SERVICE BULLETIN

TENSION SPRINGS ON EXHAUST SYSTEM

FOR ROTAX® ENGINE TYPE 582UL

SB-2ST-001

Bild / Fig. 1

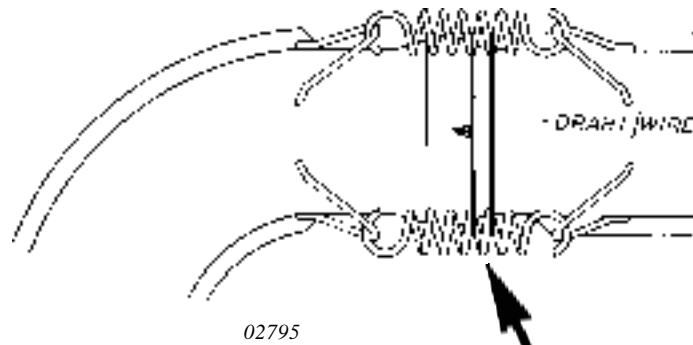
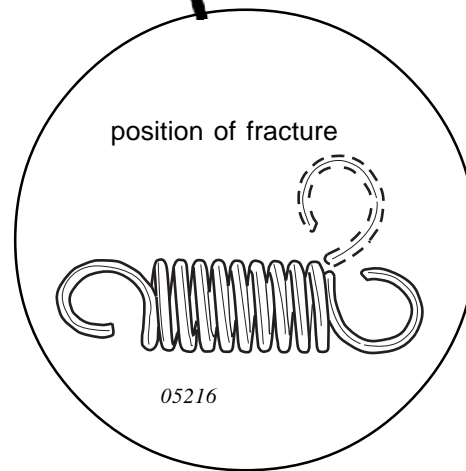
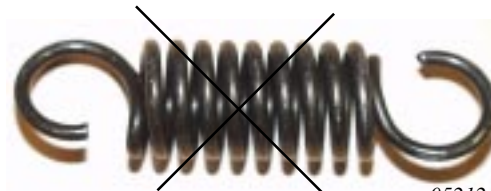
The affected (faulty) tension springs can be identified by black, bright surfaces.

Qualitatively flawless tension springs show a dark brown, dull surface.

In order
Surface: dark brown, dull

Faulty
Surface: black, bright

- Install new tension springs with appropriate tools.

- Exhaust springs shall be secured against loss and vibrations with wire.

See Fig. 1.
